**RECOMMENDATION  
MEETING  
JULY 8, 2015  
6:30PM**

**PROJECT # 3018035 1305 E. MARION ST**

**PROPOSAL:**

Existing Site - Exceptional Tree in Center

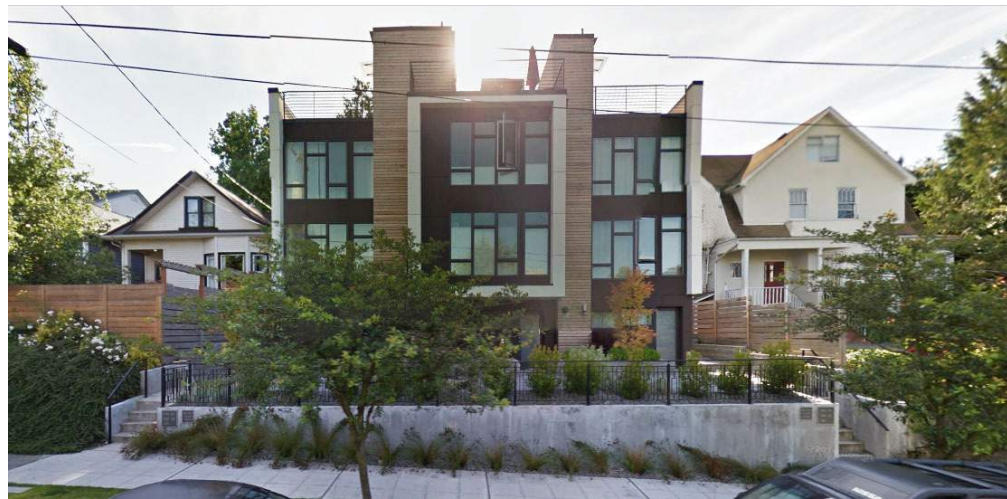
**3. Public Life: Street-Level Interaction.** The proposed design sets back from the Exceptional Tree on site, creating an increased setback from the public right-of-way.

a. The Board expressed concern about the distance between the structure and the street, noting that a strong street edge at this location would be a better response. The Board recommended further exploration of moving the structure closer to the street. (CS2-D, PL1-B, PL2-B, PL3-B, DC1-A, DC2, DC4-A)

b. In consideration of moving the structure closer to the street, the Board questioned the requirements for preservation of the Exceptional Tree on site. The Board requested that the Recommendation packet contain the required tree protection area dimensions. (DC3)

c. To encourage privacy and security with eyes on the street, the Board encouraged moving the internal circulation to the center of the structure, allowing for units at the corners. (PL2-B, PL3-B, DC3)

d. The Board recommended additional glazing at street-level street-facing façade to support the creation of a safe environment by providing lines of sight and encouraging natural surveillance (PL2-B, PL3-A, PL3-B, DC1-A).

**RESPONSE:** The proposed setback from the original proposal was reduced from 12' to the minimum 5' at the ROW on the north side. We feel that reducing that setback effectively supports natural surveillance with the large amount of glazing proposed (42.4% glazing percentage).

**DEPARTURE SUMMARY**

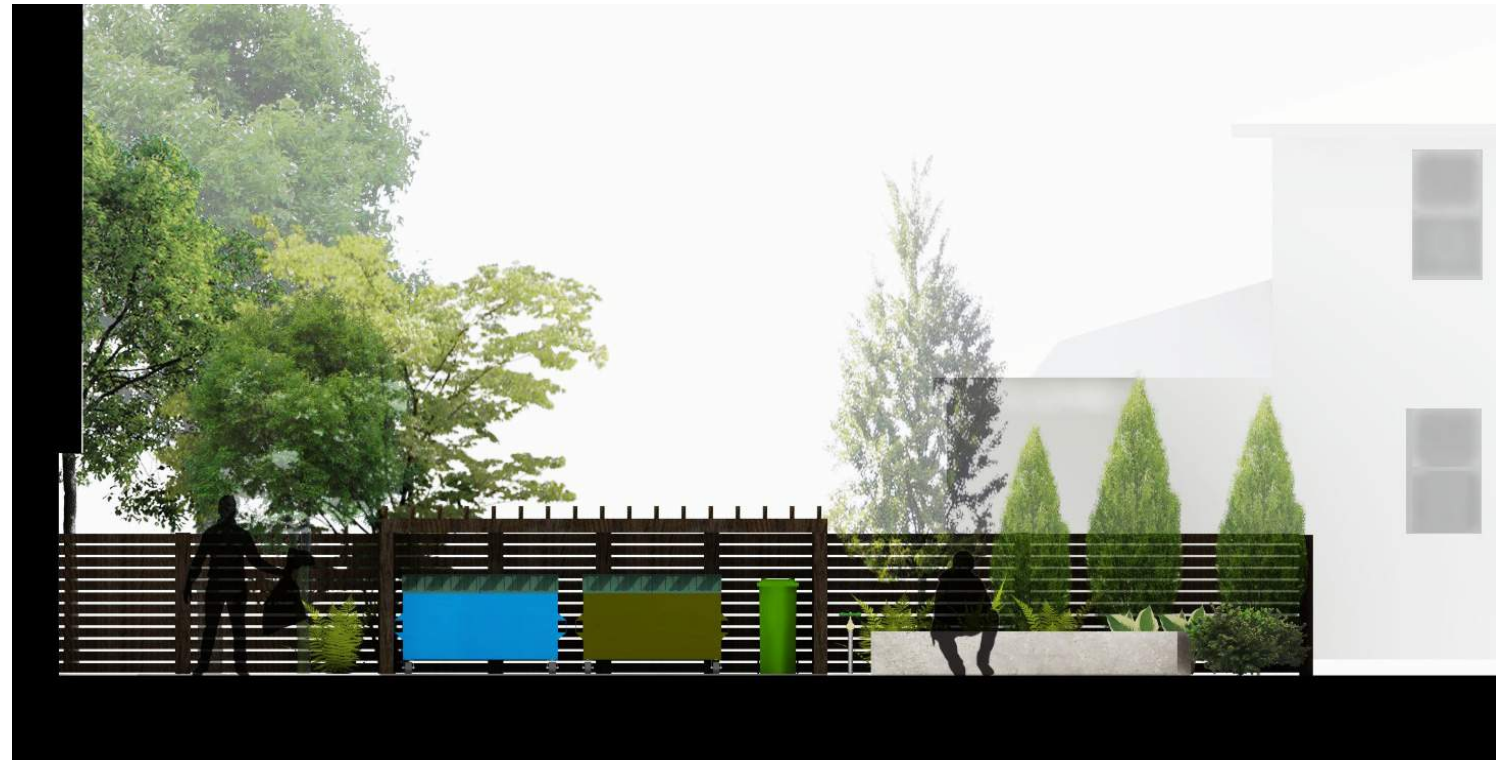
- 1. 23.45.522.A** To allow for less than 25% of total lot area in amenity space.

- 2. 23.45.522.D.5.b.1** To allow for less than 50% planting space in amenity area.

**RATIONALE:** The board agreed Option 2 presented the best response to the context and site by proposing a central courtyard to be used by the project and adjacent apartment on site. This courtyard encourages a connection between the two structures (PL1-B, PL1-C, DC3). Furthermore, this proposal allows us to provide greater amounts of bicycle parking area, and will encourage active forms of transportation (PL4). 41.1% planting space is proposed within the total amenity area, and the .60 Green Factor is met.
